**HUDSON RIVER PCBs REASSESSMENT RI/FS  
RESPONSIVENESS SUMMARY FOR  
VOLUME 2A: DATABASE REPORT  
VOLUME 2B: PRELIMINARY MODEL CALIBRATION REPORT  
VOLUME 2C: DATA EVALUATION AND INTERPRETATION REPORT**

**DECEMBER 1998**

**U.S. Environmental Protection Agency  
Region II  
and  
U.S. Army Corps of Engineers  
Kansas City District**

**TAMS Consultants, Inc.  
Limno-Tech, Inc.  
TetraTech, Inc.  
Menzie-Cura & Associates, Inc.**

Figure DG-1.20B  
 Total PCBs vs. the GE/HydroQual Dechlorination Ratios  
 for the High Resolution Core Data (Lower Hudson Freshwater)

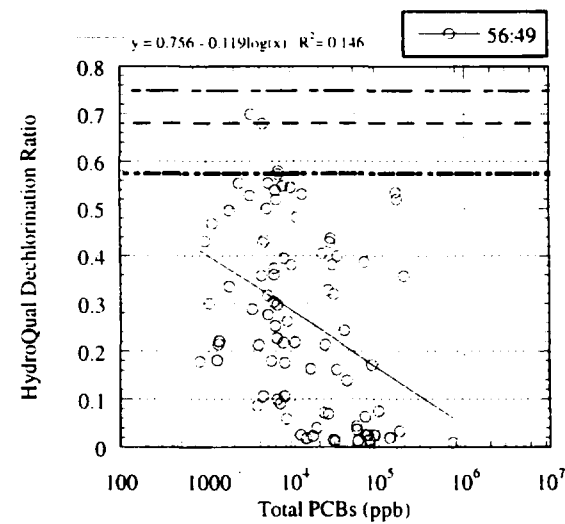
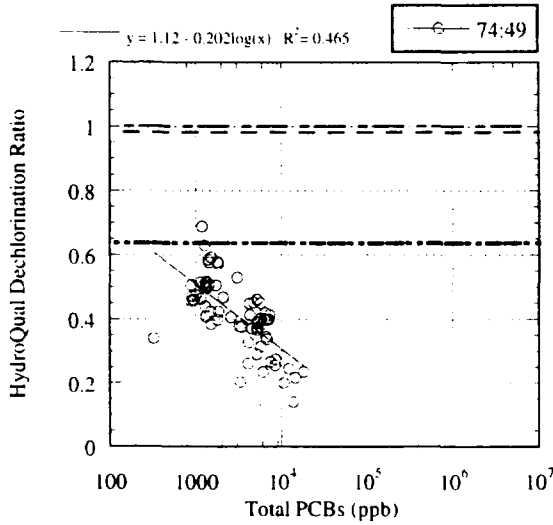
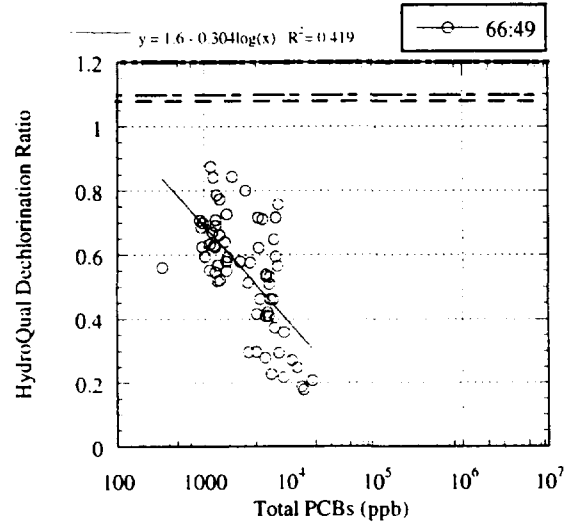
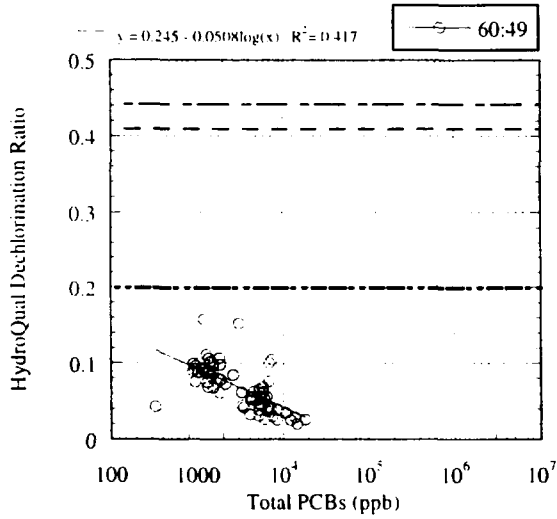
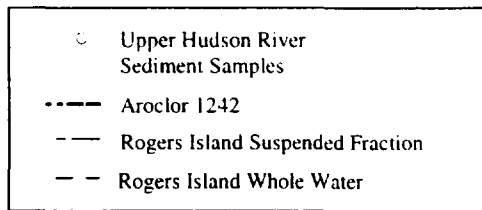
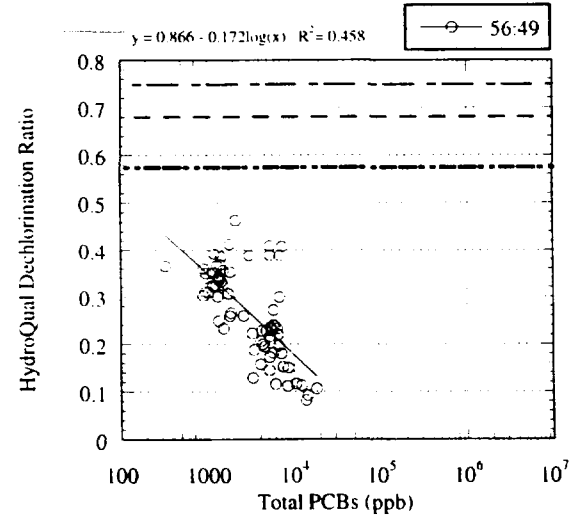
#### Response to DG-1.20

The H, H' ratios of the Lower Hudson sediments show a weak decline with total PCB mass. However, this decline does not correspond to a substantive change in the number of chlorines per biphenyl, as shown in Figure DG-1.20D. This is also evident in Figure DG-1.19A which shows only a weak correlation between Cl/BP and these ratios for the Upper Hudson
